## **Product Change Notice (PCN)**

PCN Number: PCN-0450024R-01

Product(s) Affected: PJ-075DH-SMT-TR

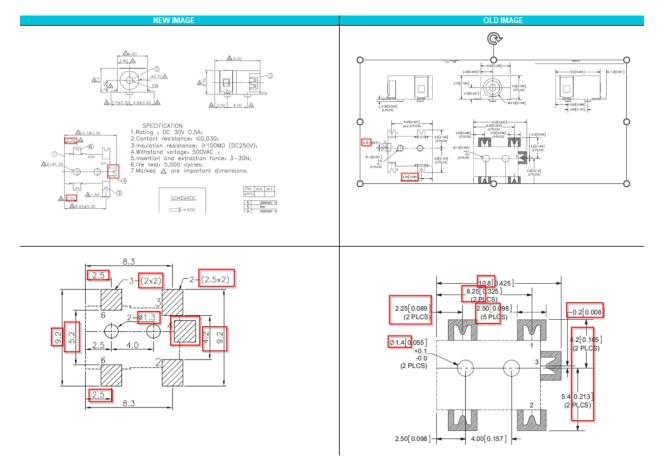
Description of Change: Minor Housing and footprint differences. Material Change on the

housing and terminals. See image Below

Housing and Terminal Material Changes:

Center Pin: Copper to Brass Terminal 2: Copper Alloy to Brass Plastic: PA6T or Equivalent to PA9T
